CR NEMBA Proposed “Birthday Hill Trail”

- CR NEMBA Proposal
 - Allow bike use on 1.5 mile management road/snowmobile trail segment along south Bigelow Preserve boundary
 - Purpose: “connector trail in existing network, challenging climb/descent”
- Dominant Resource Allocation
 - Bigelow Backcountry

Dominant Resource Allocations in Vicinity of Proposed Trail

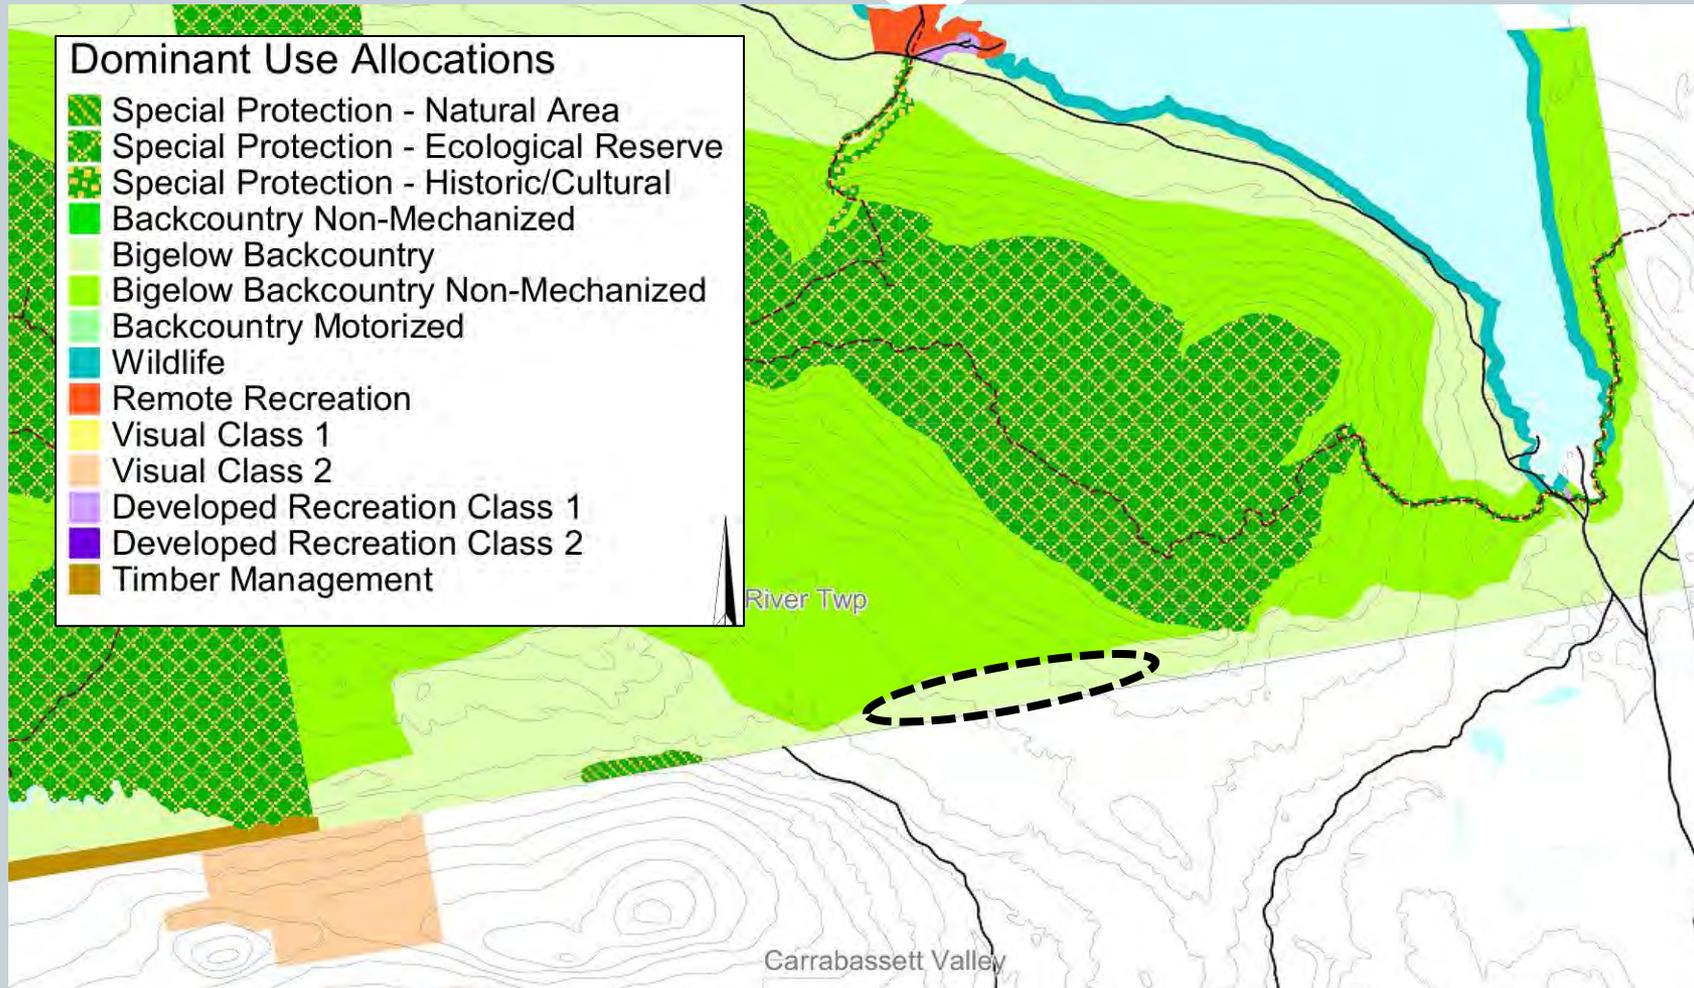
- Concerns/Constraints
 - Does not link directly to any other designated bike trails (although existing snowmobile/ATV route between the Carriage Road and Huston Brook Road is reportedly ridden now)
 - Riders seeking challenge may be tempted to ride on “winter roads” branching north (upslope) from this road

- Justifications for Approval of Concept
 - No new ground disturbance (existing management road used informally by bike riders)
 - Road links directly to snowmobile/ATV routes on adjacent lands that are used by mountain bike riders
 - Road links indirectly to the 60s Road/Esker Trail and regional bike trail network via Huston Brook Road and the Carriage Road
 - Provides gradual climb (most other bike trails and management roads open to bikes in Preserve are generally flat) for riders seeking more physical challenge

- Allow mountain bike use of road/snowmobile trail segment as a connector trail by adding to list of management roads designated for mountain bike use
- BPL will block as needed any associated winter roads and will monitor for unauthorized bike use of those roads
- Consistent with current policy on mountain bike use within the Bigelow Preserve, road will not be formally designated **as a “bike trail”**
- BPL may use the road as a haul route during future timber harvests, and log yards could be constructed along the road

CR NEMBA Proposed “Esker Trail” reroute

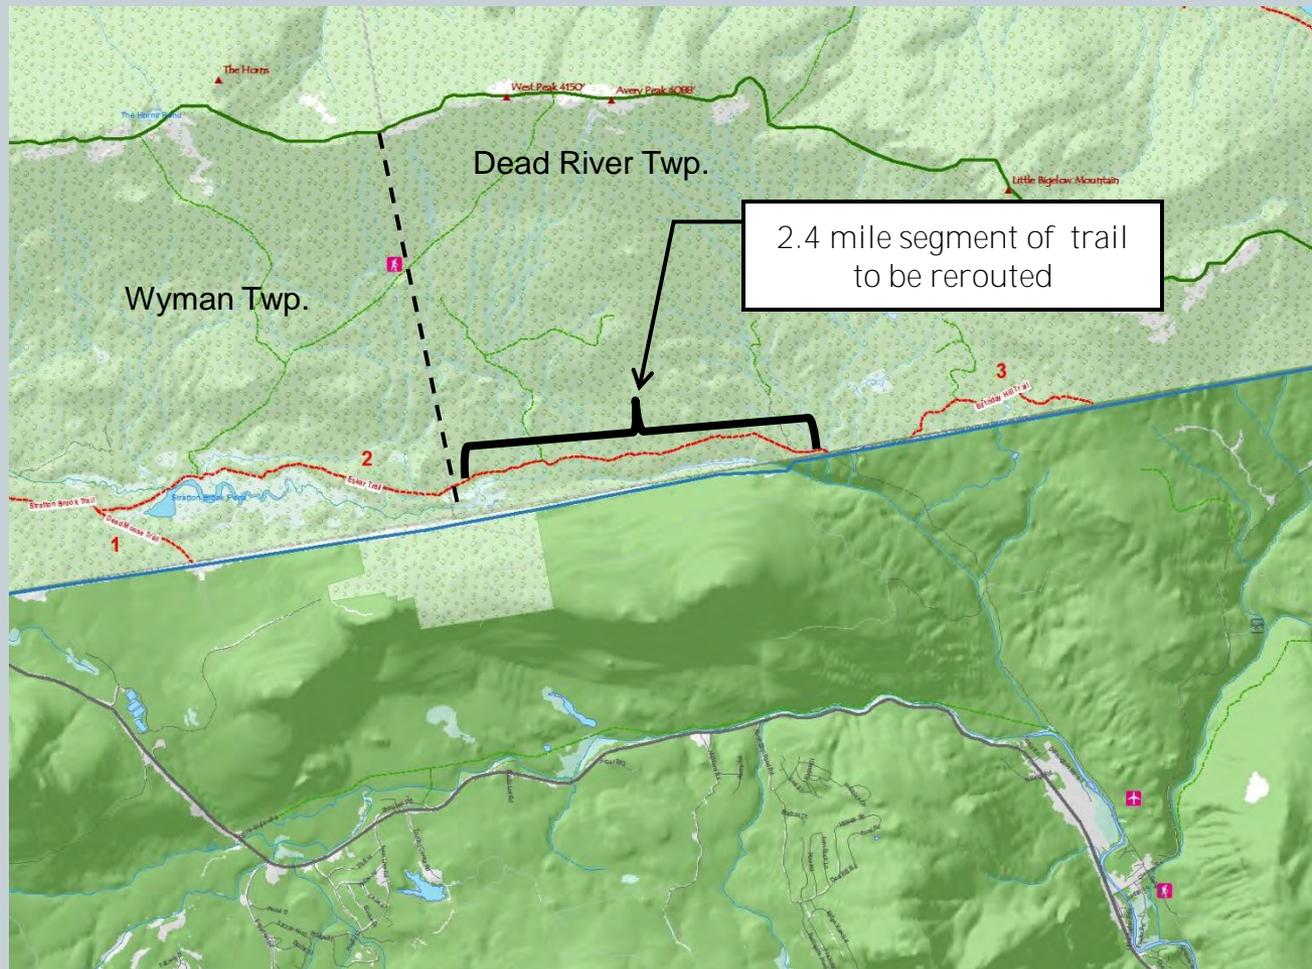
- Rerouted trail would represent new recreational development and require new ground disturbance in Bigelow Preserve
- Construction of single-track trail may be perceived as setting a precedent for bike trails in the Bigelow Preserve on other than existing public use and management roads
- Availability of resources to construct rerouted trail ahead of planned harvests
- Necessity to avoid potential impacts to Huston Brook Pond and its buffer zone (allocated Special Protection)

- Justification for Approval of Concept
 - Trail is key East-West mtn. bike route in south part of Bigelow Preserve, linking Huston Brook Road and Stratton Brook Road
 - Timber harvesting activity will close bike route for 2 seasons, possibly beginning in 2016
 - Upgrade of road for planned harvest would substantially change the riding experience when the trail is reopened
 - ✦ Would no longer approximate single track riding
 - ✦ Would become similar to riding on other management roads in the Preserve, with a wide cleared ROW and graveled surface
 - Concept replaces rather than creates an additional route for mountain bikes
 - Concept does not open up a new area of the Preserve to bike riding
 - Single-track trail can be constructed sustainably and with minimal ground disturbance

- Collaborate with CR NEMBA on specific route and design for ~2.4 miles of rerouted trail, with intention **of providing a “single track” trail**
- Trail will cross only areas allocated Bigelow Backcountry and will avoid the Special Protection zone around Huston Brook Pond
- Trail to be constructed by CR NEMBA
- If beaver flowage half mile east of township/county line is not avoided by reroute, consider improving crossing to facilitate trail use during occasional flooding

Dominant Resource Allocations in Vicinity of Proposed Trail Reroute

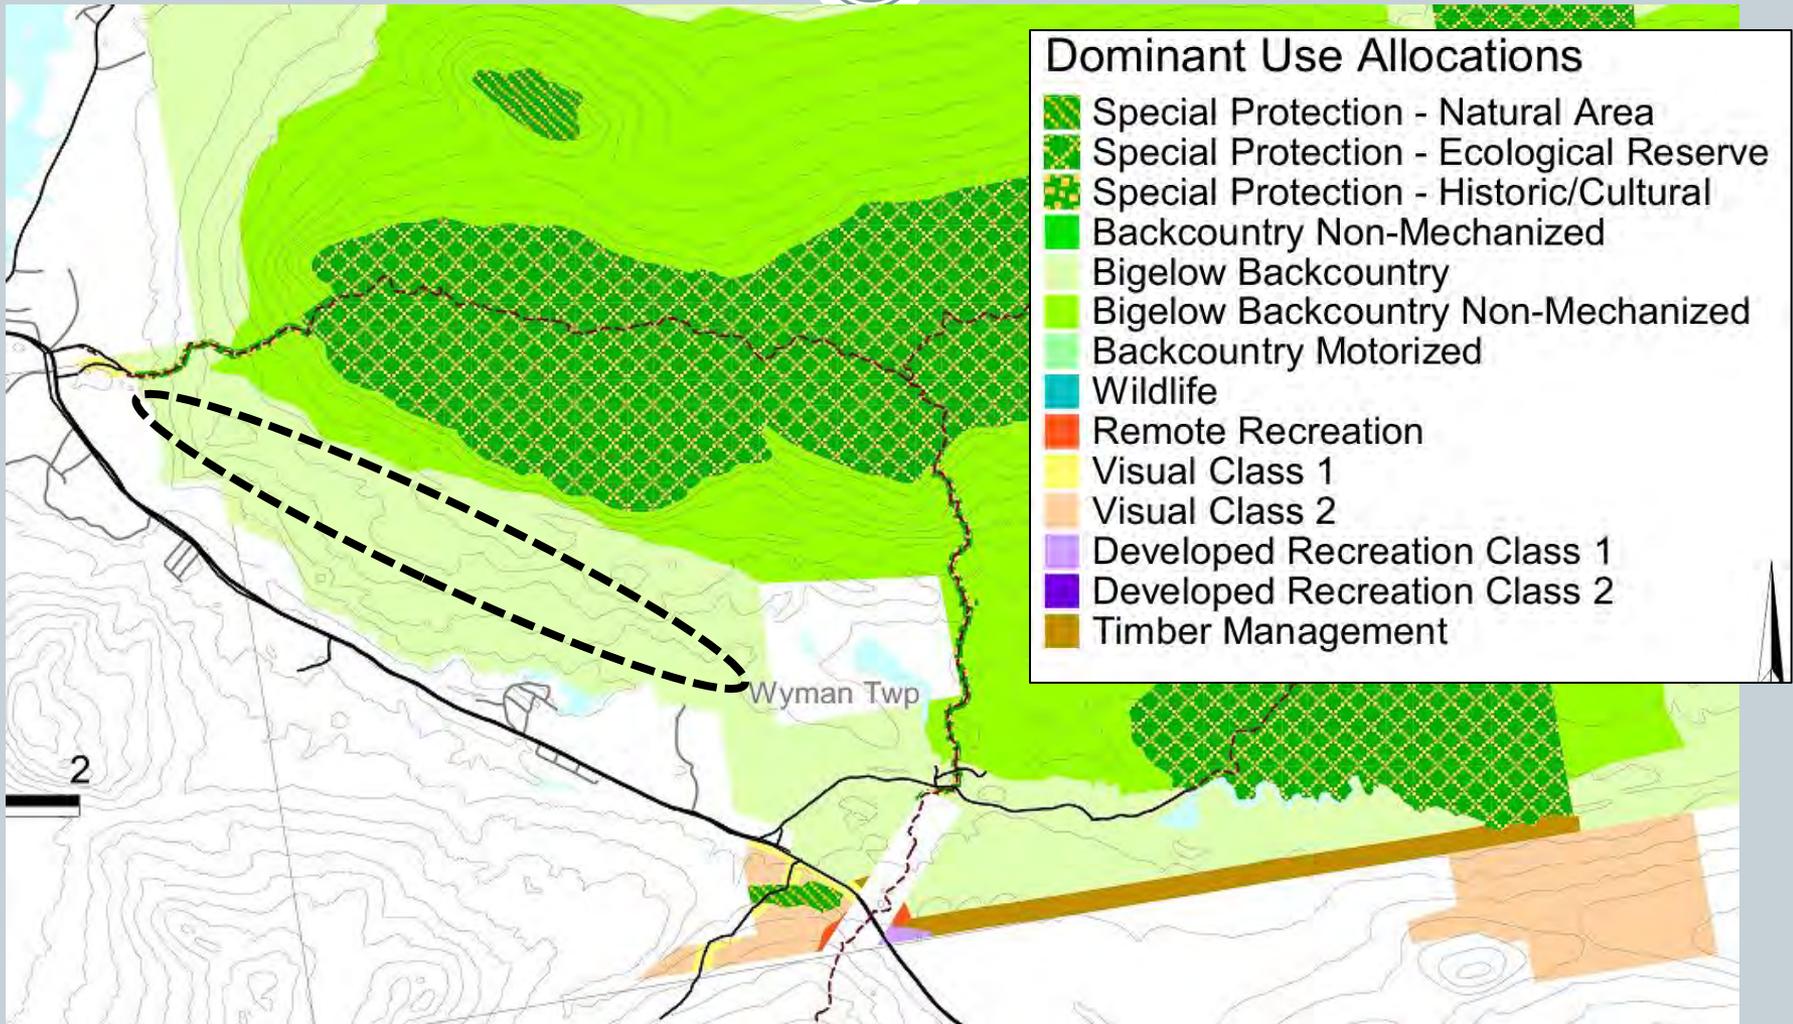
- Concerns/Constraints
 - Wet areas within westernmost mile of currently designated trail (“winter road” section) are not in desired condition for bike use
 - Entirely rerouted trail to provide alternative to management road riding would entail 5 miles of new trail in Bigelow Preserve, raising concern about overdevelopment in “Bigelow Backcountry” and preservation of “overall natural character” of the Preserve

- Justification for Approval of Concept
 - Road has already been designated for mountain bike use (page 126 of Plan)
 - **Eastern 4 miles of trail is “surfaced summer road” in good condition for bike use**
 - Provides bike route connecting Carrabassett Valley to Stratton community

- Work with CR NEMBA to plan improvements on existing management road/snowmobile trail to facilitate bike use and improve riding experience, with limited reroutes in problem areas
- Improvements must be compatible with snowmobile use of the trail corridor
- Improvements to be constructed by CR NEMBA

CR NEMBA Proposed “Backside Trail”

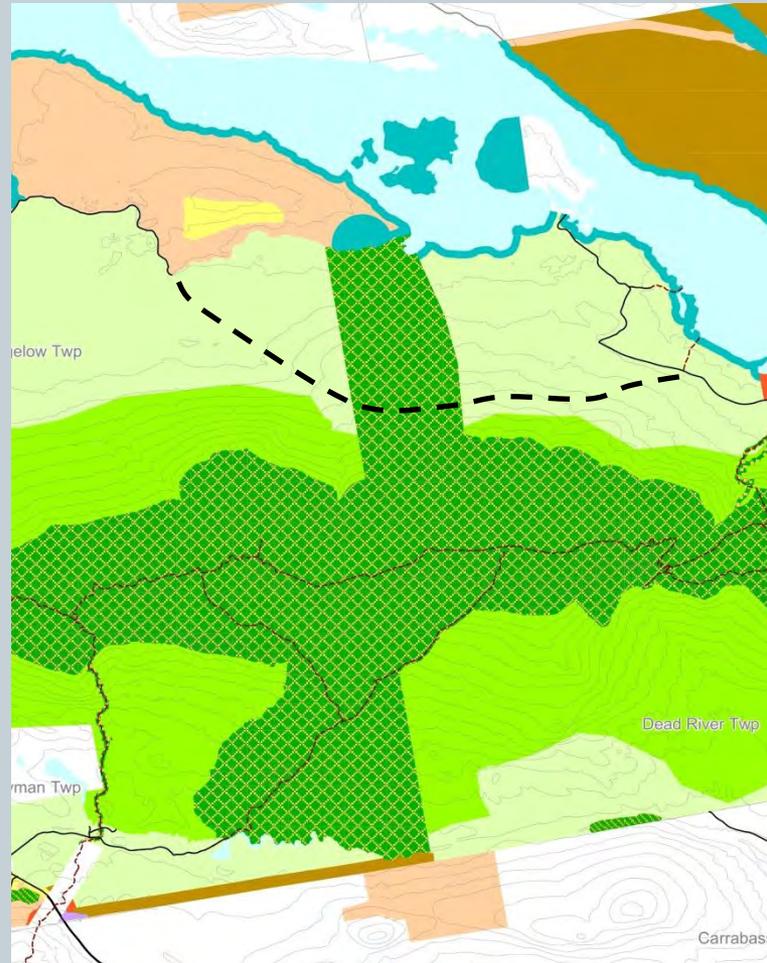
- No Plan Amendment is proposed
 - **Conflicts with Plan’s objective to minimize further summer trail development on the northern slope and to locate mtn. bike trails “outside a core non-mechanized area” (p. 126), which includes the ecoreserve (Special Protection dominant use allocation)**
 - **Conflicts with desire to limit additional recreation development in the Preserve, in keeping with Vision: “trails and facilities proposed in this Plan...approach the limits of...the maximum appropriate level” (p. 116)**

Redington Lot Resource Allocations and Roads

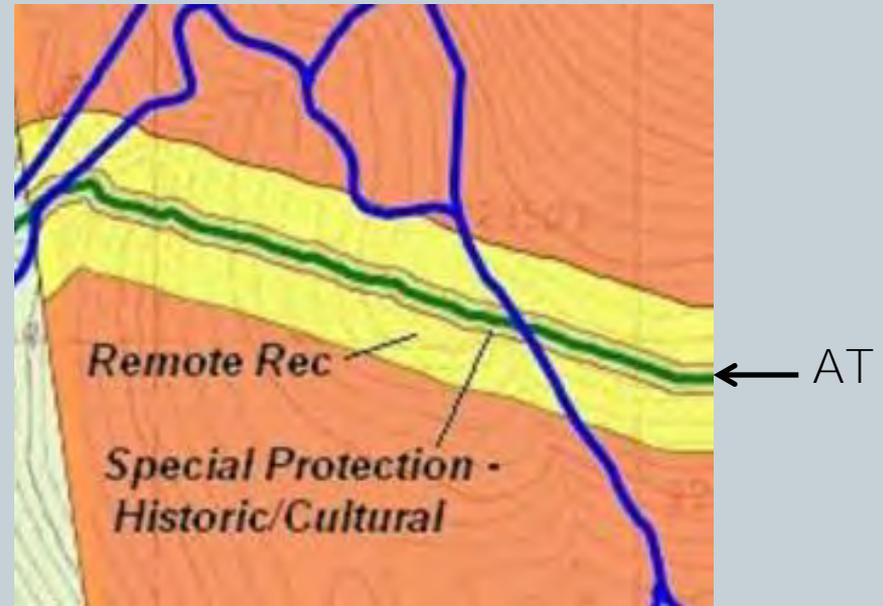
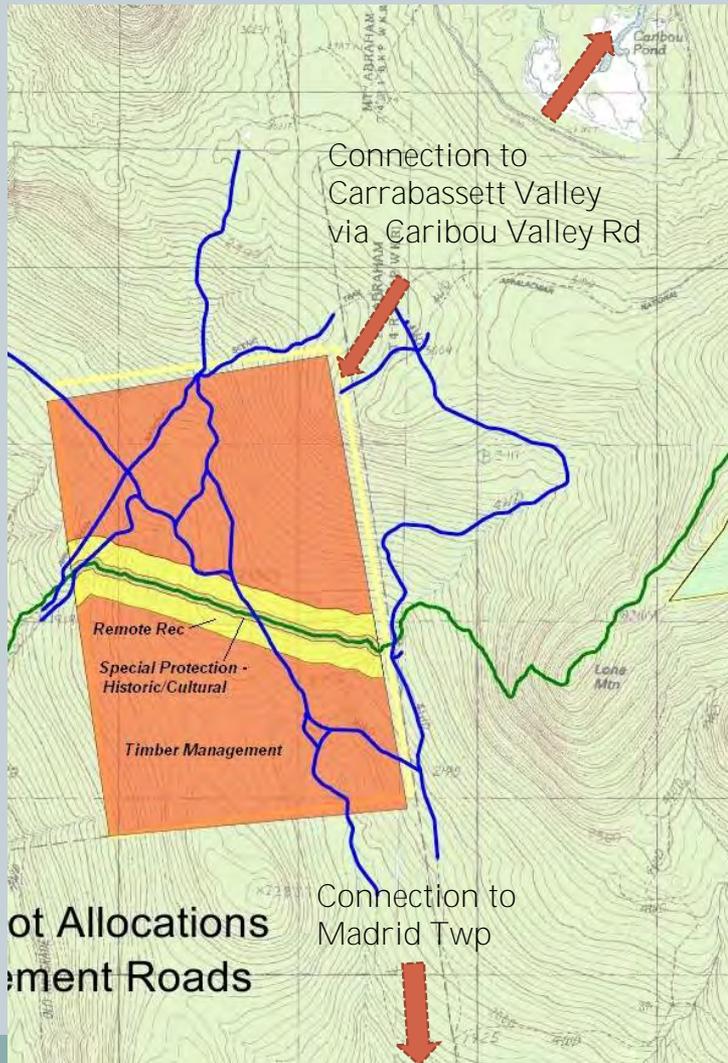
- Concerns/Constraints
 - Current Plan does not allow new motorized recreation trails within 500 feet of the AT (within the Special Prot./Remote Rec. buffer)

- **IRP does not allow new motorized trails in “natural” or “historic/cultural” Special Protection areas (page 12)**
 - IRP requires that adjacent landowner approval be sought and received before planned trail connections are approved (page 64); Abutters = Sugarloaf Corp to north, Wagner to south

- Some organizations and members of local trails community oppose development of motorized trails in core of High Peaks area
 - **Potential for impacts on AT and disturbance of AT hiker’s experience** associated with motorized/mechanized activity (e.g., mountain bikes and ATVs during summer)

- New trail construction would likely be required on Redington Lot within TM area, where separate motorized (ATV and snowmobile) and **“mechanically assisted” (mtn. bike and groomed ski) trails are desired**, which may conflict with timber management

- Dominant Resource allocations
 - Reallocate 100-foot Special Protection buffer to Remote Recreation in the immediate vicinity of management road crossing of AT
 - Allow new motorized recreation trail within 500 feet of the AT (within the Remote Recreation buffer); IRP allows if meet 3 criteria
- Management Recommendations
 - Collaborate with regional trail organizations (e.g., snowmobile and ATV clubs, CR-NEMBA, MH&T, MATC) to develop the best trail alignment on BPL and adjoining properties that would utilize a shared AT crossing on existing management road and shared or, potentially, separate motorized and non-motorized trails on and off the lot
 - Develop plan with AT organizations to control and monitor mountain bike and motorized use at AT crossing to ensure no trespass onto AT and to minimize potential conflicts with hikers

Dominant Resource Allocations in Vicinity of Proposed Boat Launch – Dead River Peninsula Site

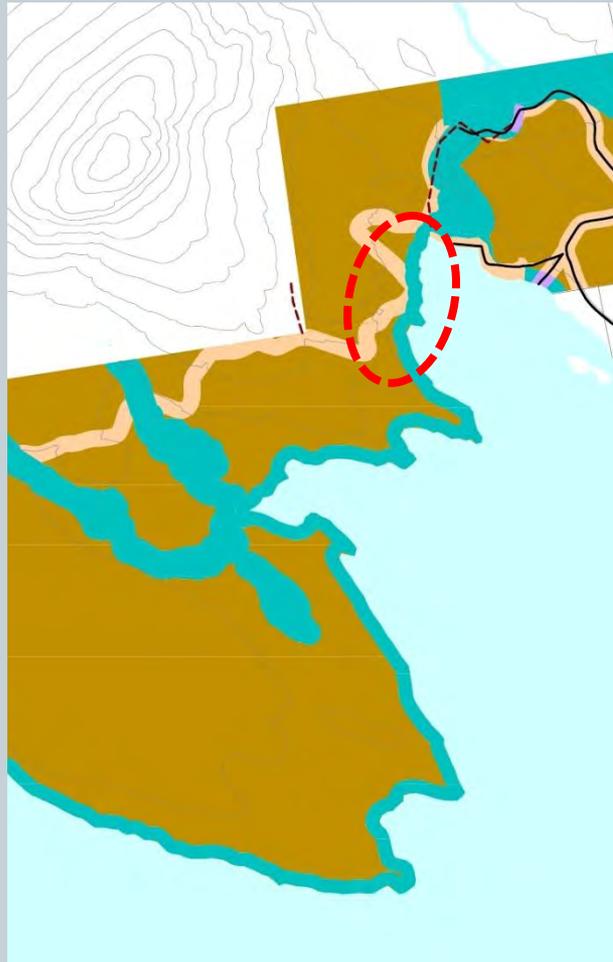
- ✦ Development would likely involve more new ground disturbance and would be more costly than Gravel Pit site
- ✦ Considerable distance (10+ miles) from existing Bog Brook launch that new launch would replace and less accessible from nearby communities
- ✦ Remoteness of site may make it more vulnerable to abuse and other management problems

- If Dead River Peninsula site selected:
 - Revise Dominant Allocation from Wildlife and Timber Management (if applicable) to Developed Recreation Class I in area of launch ramp
 - Construct a new gravel trailered boat launch ramp with parking for 4-6 vehicles and trailers, with access via the North Flagstaff Road
 - Collaborate with Boating Facilities Program and Brookfield on siting, design, permitting, and construction of facility
 - Consider site maintenance arrangement using Camp Host volunteer stationed at Big Eddy
